Work Order ID 94000

Item Name: Crosstube Turning Detail

<b>DART AEROSPACE LTD</b>	<b>Work Order:</b>	<b>94000</b>
<b>Description:</b> Crosstube Assembly (412 High Aft)	<b>Part Number:</b>	<b>D412-664-243</b>
<b>Inspection Dwg:</b> D412-664-243 <b>Rev:</b> E		<b>Page 1 of 2</b>

DRAWING NO. D412-664-243	TITLE CROSSTUBE ASSEMBLY (412 HI AFT)	REV. E	DART AEROSPACE LTD ENGINEERING ORDER		D.E.O. NO. D412-664-243-E-1	SHEET NO. SHEET 1 OF 2	SCALE NTS
DRAWN	CHECKED	MFG. APPR.	APPROVED	DE APPR.			
DATE 11.03.31	DATE 11/03/31	DATE 11.03.31	DATE 11/03/31	DATE 11.03.31

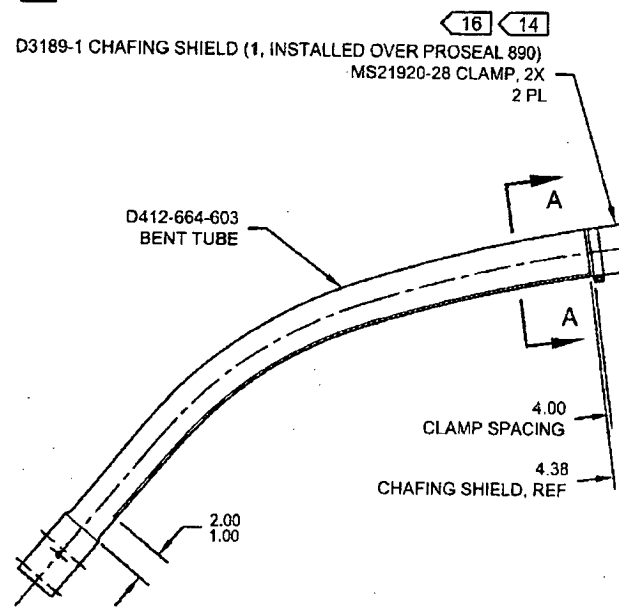
REMOVED ABRASION STRIP IN FAVOR OF A THIN LAYER OF PROSEAL 890. UPDATE INSTALLATION OF CHAFING SHIELDS AND REDUCE TORQUE TO 40-50 IN-LBS. THIS ENGINEERING ORDER SUPERCEDES DEO D412-664-243-E-1.

**NOTES 2, 14, AND 16 ON SHEET 1 ARE AMENDED AS FOLLOWS:**

- 2) FINISH: CHEMICAL CONVERSION COAT PER DART QSI 005 4.1  
PRIME INSIDE AND OUTSIDE PER DART QSI 005 4.2  
MASK UNDERSIDE OF CROSSTUBE AS SHOWN (HATCHED AREA)  
PAINT OUTSIDE PER DART QSI 005 4.2  
AFTER PAINTING, APPLY CLEAR COAT ON HATCHED AREA
- 14) APPLY A THIN COAT OF PROSEAL 890 ON INSIDE CONCAVE SURFACE OF D3189-1 CHAFING SHIELD AND LET CURE PER MANUFACTURER'S INSTRUCTIONS. INSTALL PROSEALED D3189-1 CHAFING SHIELD ONTO CROSSTUBE BY APPLYING A THIN COAT OF PROSEAL 890 ONTO CROSSTUBE. BE SURE TO ELIMINATE ANY AIR GAPS.
- 16) TORQUE CLAMPS ON D2896-1 SUPPORT 80 TO 100 IN-LB. **TORQUE CLAMPS ON D3189-1 CHAFING SHIELD 40 TO 50 IN-LB.** ENSURE AT LEAST 1.5 THREADS SHOWING IN SAFETY AND THAT NUT HAS NOT BOTTOMED-OUT AFTER TORQUING.
